Addendum

Addendum Number: 1
Addendum Date: 8/23/21
Written To: Max Kasper
Project Name: Swampscott Middle School Hydronics Upgrades
CES Project Number: 2021333.00
Written By: David Hillburn, PE

**SWAMPSCOTT
MIDDLE SCHOOL
HOT WATER
HEATING SYSTEM
UPGRADE**

1 BASEMENT MEP NEW WORK PLAN
SCALE: 1/4" = 1'-0"

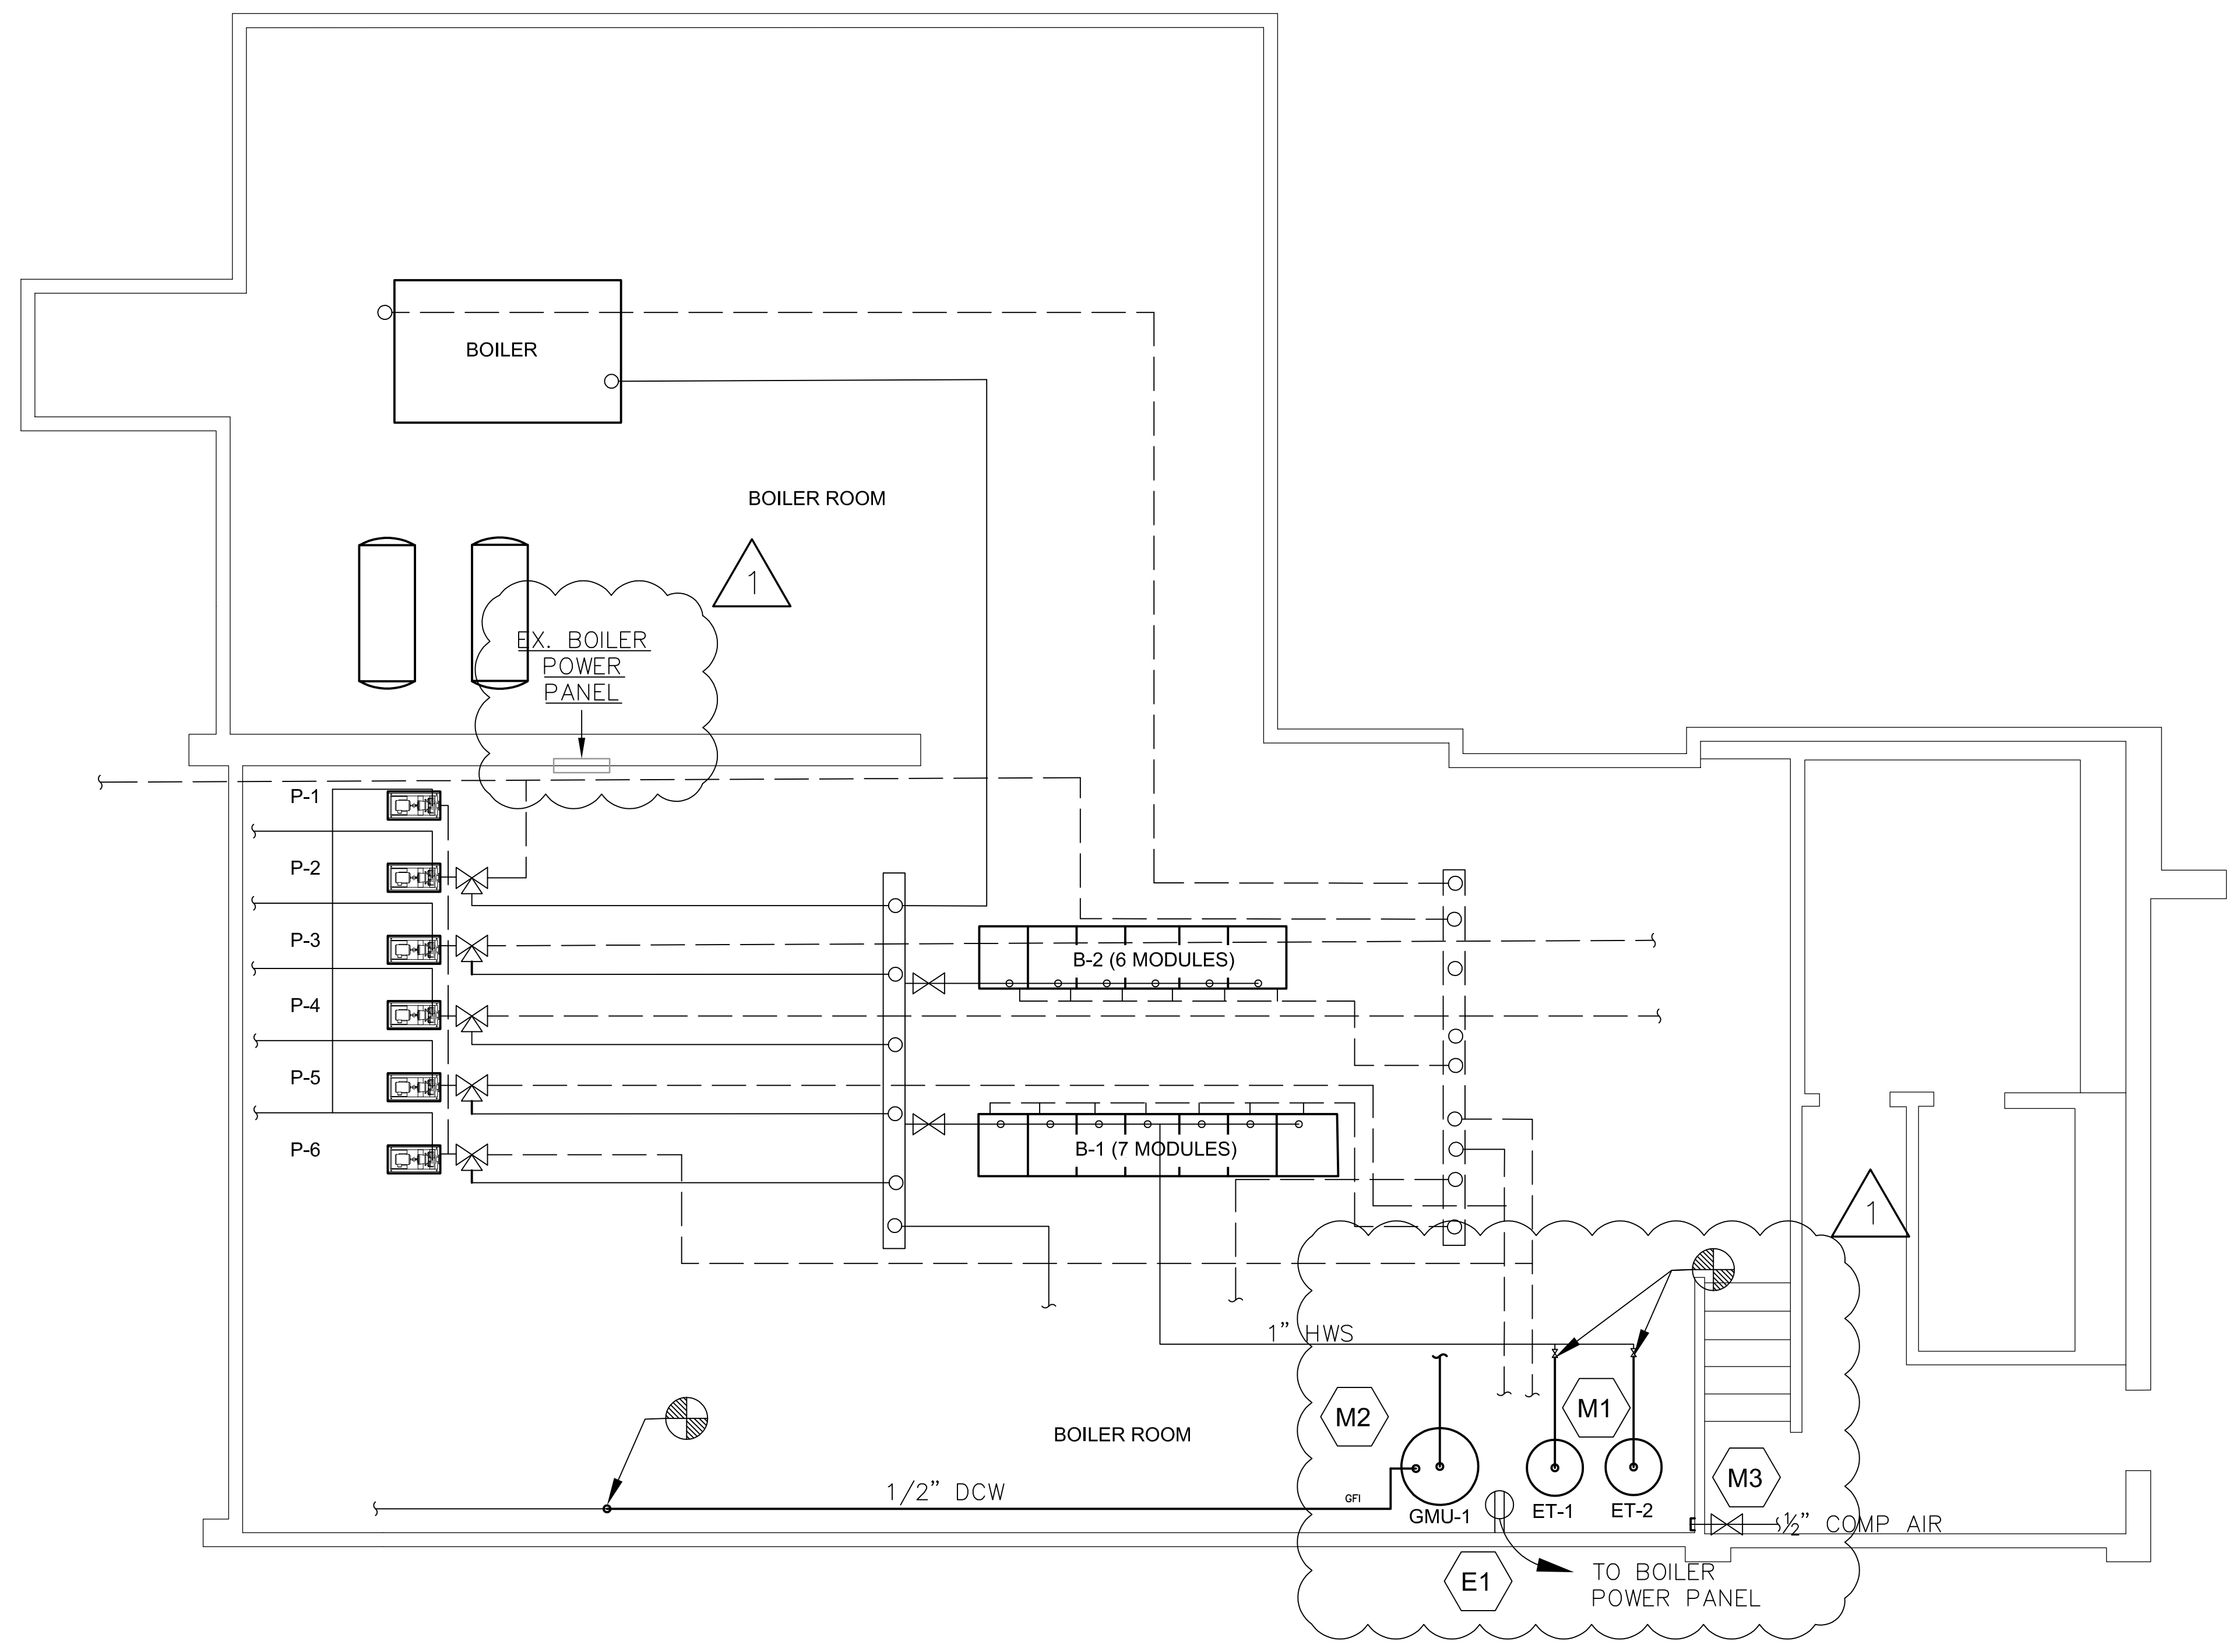
MEP-1: ADD ET-2 to new work floor plan. ADD existing boiler panel as power for new circuit on floor plan and keynote 1.

M1 PROVIDE NEW EXPANSION TANKS AND CONNECT TO EXISTING HOT WATER HEATING SYSTEM PER DETAIL 1 SHT MEP-5.

E1 PROVIDE 120V, 20A, GFCI OUTLET MOUNTED 18" AFF FOR PLUG IN CONNECTION TO GLYCOL MAKEUP UNIT. LOCATE OUTLET WITHIN 6FT FROM UNIT. USE 2#12, #125, 3/4" C FROM NEW 15A/1P CIRCUIT BREAKER TO EXISTING GE A-SERIES AF31S BOILER POWER PANEL.

3 HOT WATER BOILER DIAGRAM - NEW WORK
N.T.S.

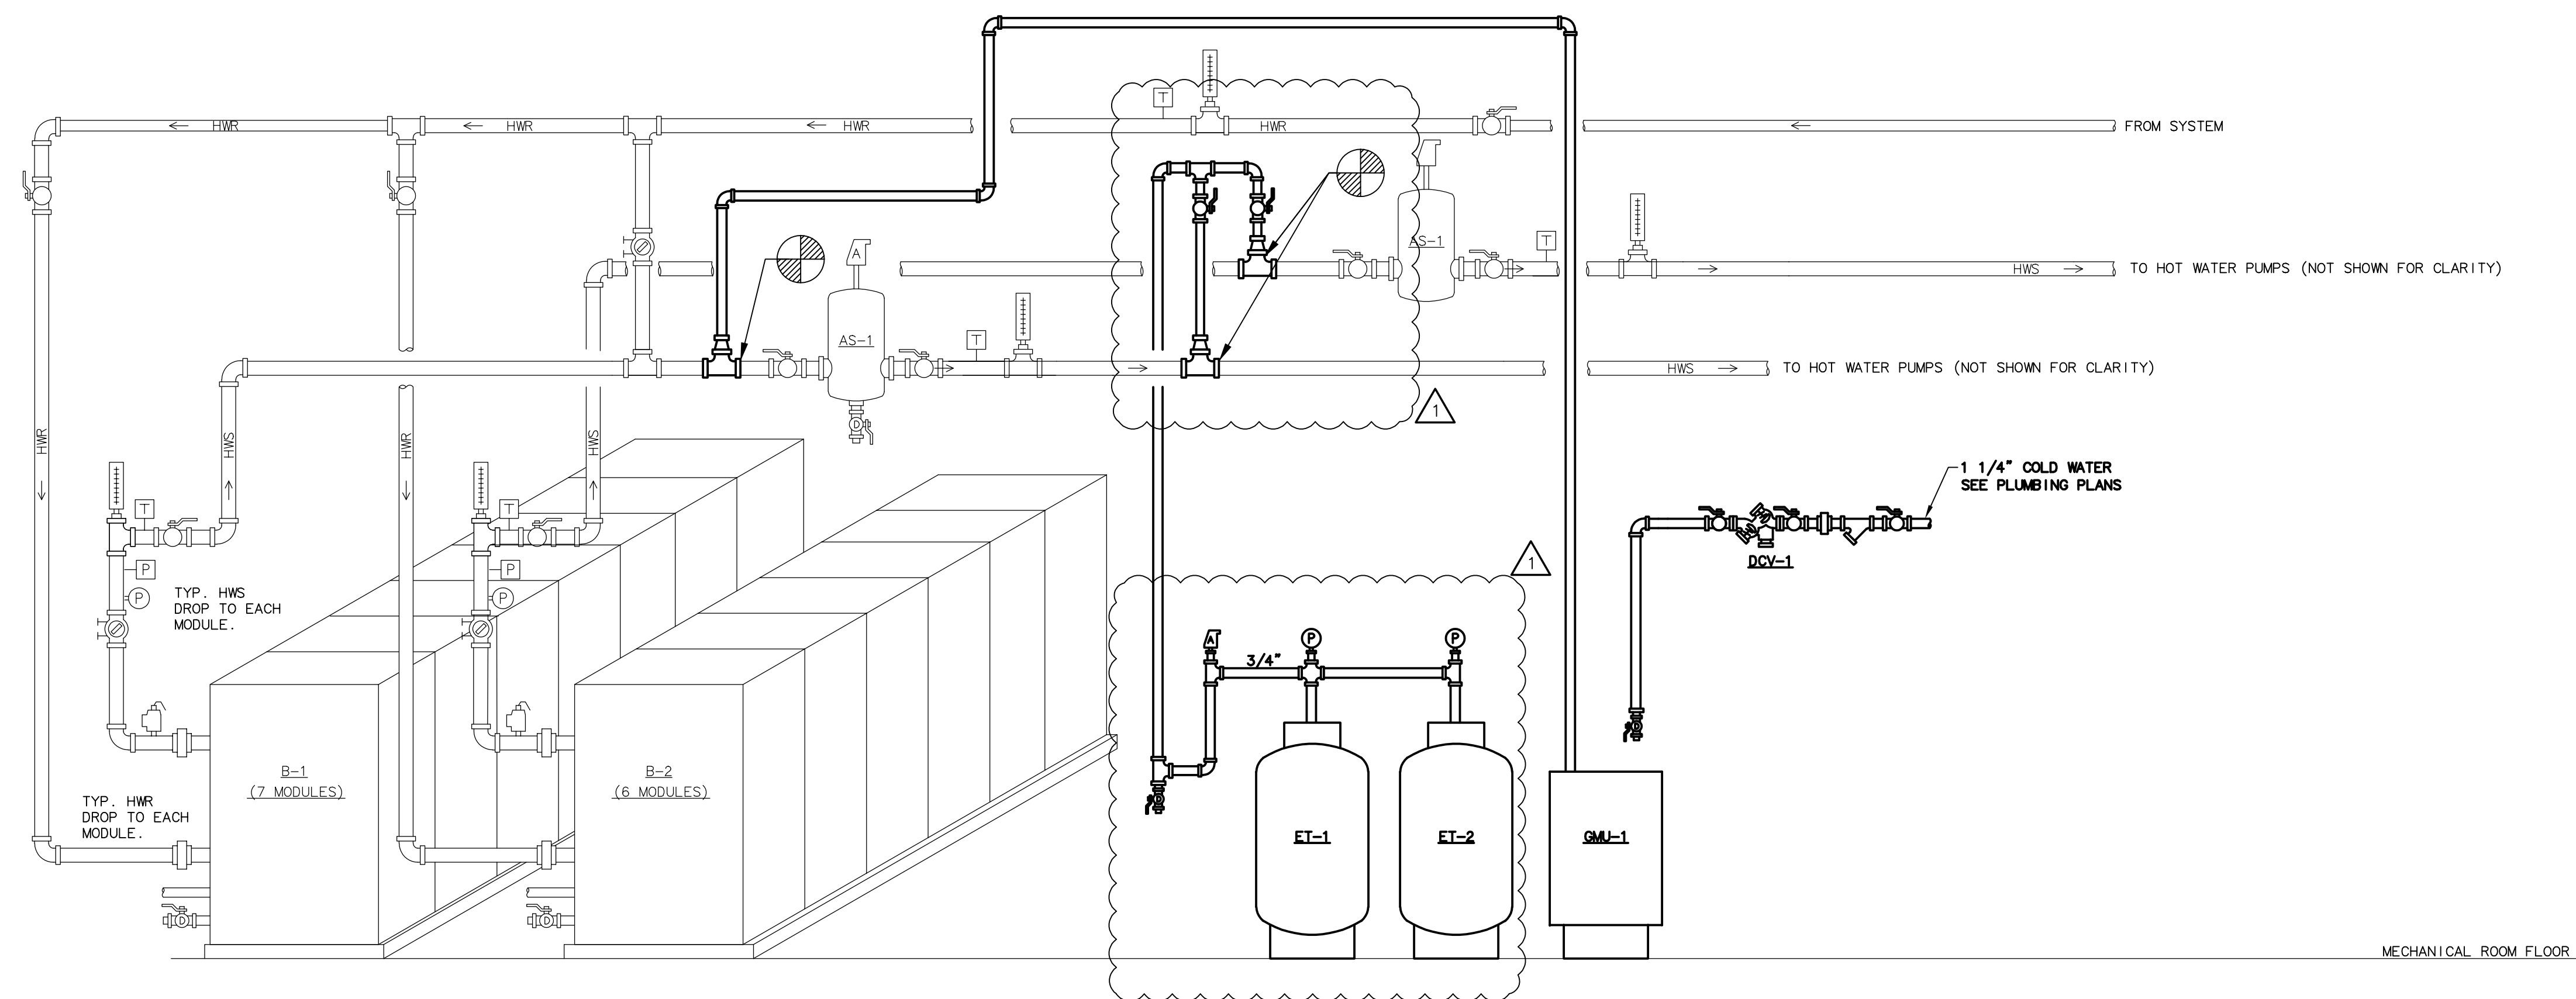
MEP-5: ADD ET-2 and piping to hot water diagram.
